Attachment N

Proposed Interim Change (219.5 kV)

SONGS Units 2 and 3

Southern California Edison Company <b>INTERIM CALCULATION          CHANGE NOTICE (ICCN)/          CALCULATION CHANGE          NOTICE (CCN)          COVER PAGE</b> SUMMARY CHANGE <input type="checkbox"/> NO <input checked="" type="checkbox"/> YES	CALC NO. <b>E4C-090</b>		ICCN NO./ PRELIM. CCN NO. <b>C - 130</b>	PAGE <b>1</b>	TOTAL NO. OF PAGES <b>64</b>
	BASE CALC. REV. <b>3</b>	UNIT <b>3</b>	CCN CONVERSION: CCN NO. <b>CCN-</b>	CALC. REV.	
	CALCULATION SUBJECT: <b>AUXILIARY SYSTEM VOLTAGE REGULATION</b>				
CALCULATION CROSS-INDEX <input checked="" type="checkbox"/> New/Updated Index Included <input type="checkbox"/> Existing Index is Complete	ENGINEERING SYSTEM NUMBER/PRIMARY STATION SYSTEM DESIGNATOR <b>1804 / PBA</b>			Q-CLASS <b>II</b>	
Site Programs / Procedure Impact? <input checked="" type="checkbox"/> NO <input type="checkbox"/> YES, AR No.	CONTROLLED PROGRAM OR DATABASE ACCORDING TO SO123-XXIV-5.1 <input checked="" type="checkbox"/> PROGRAM <input type="checkbox"/> DATABASE		PROGRAM/DATABASE NAME(S) <input type="checkbox"/> ALSO, LISTED BELOW <b>ETAP</b>	VERSION/RELEASE NO.(S) <b>5.0.0N</b>

FIGURE 3A14

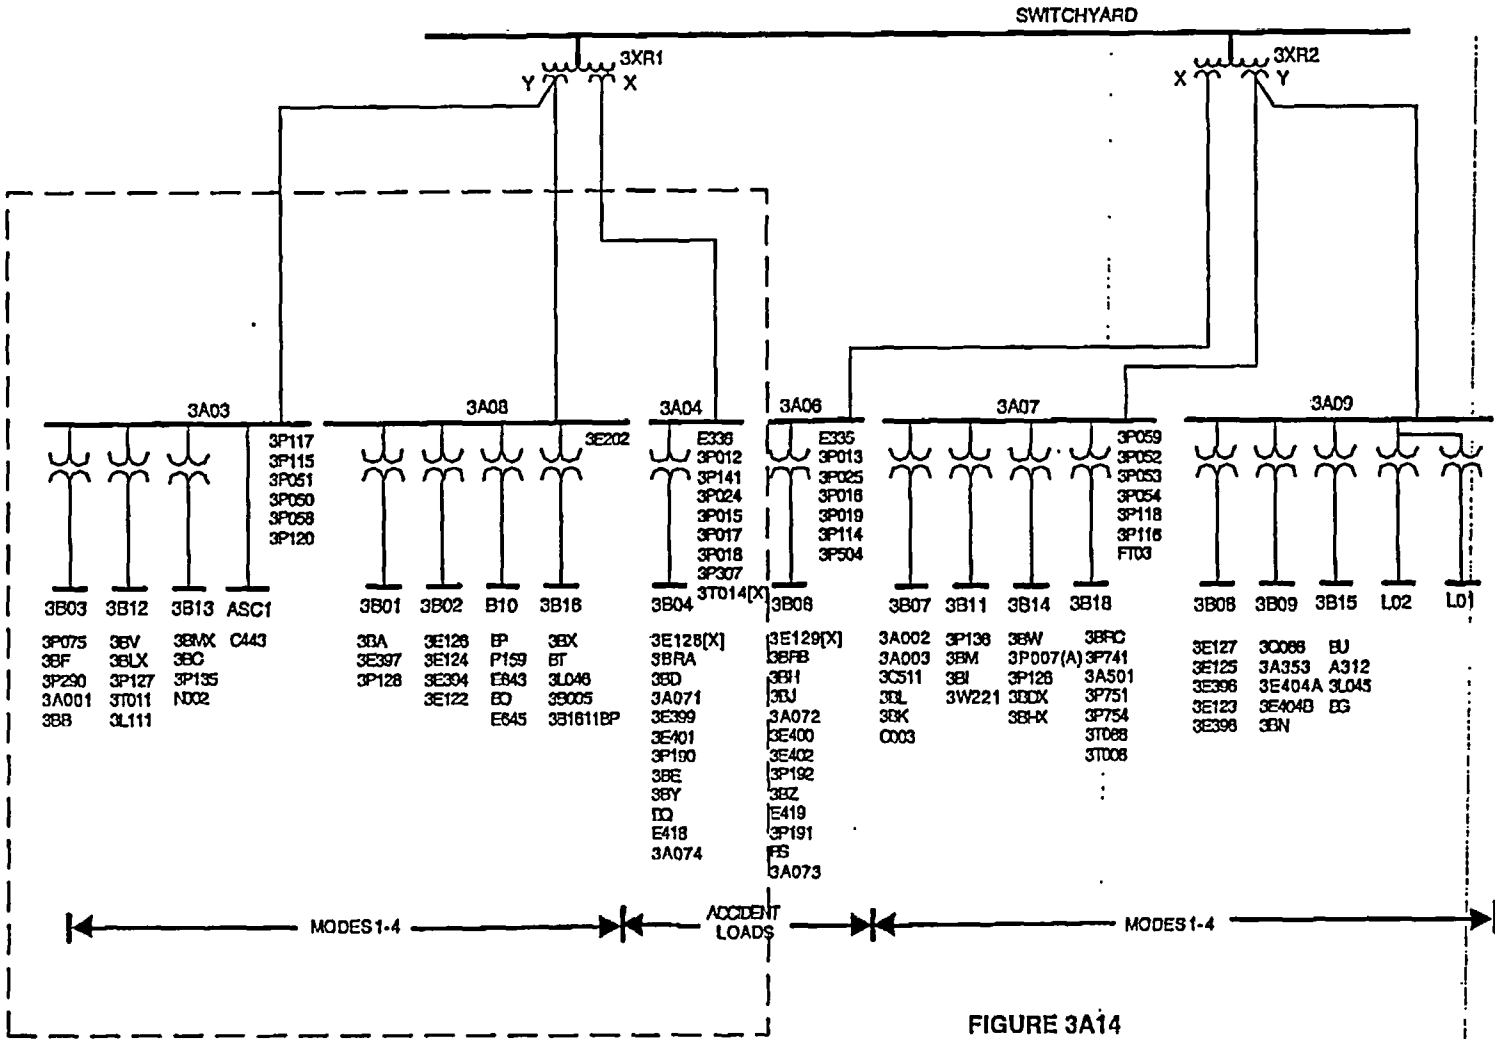
This ICCN includes accident scenario analyses only, similar to base calculation study case 3A14. However, only the affected safety train is analyzed (Unit 3, Train A) to support associated ECP. The included study case is designated as "3A14aa".

Page 4 of this ICCN includes the one-line diagram of the analyzed system.

The resultant 3A04 bus voltage derived in this ICCN is 4190V based on a postulated switchyard voltage of 219.5kV. In addition, all Class 1E loads experience a minimum terminal voltage greater than 90% rated, with 3A04 bus voltage at 4139V.
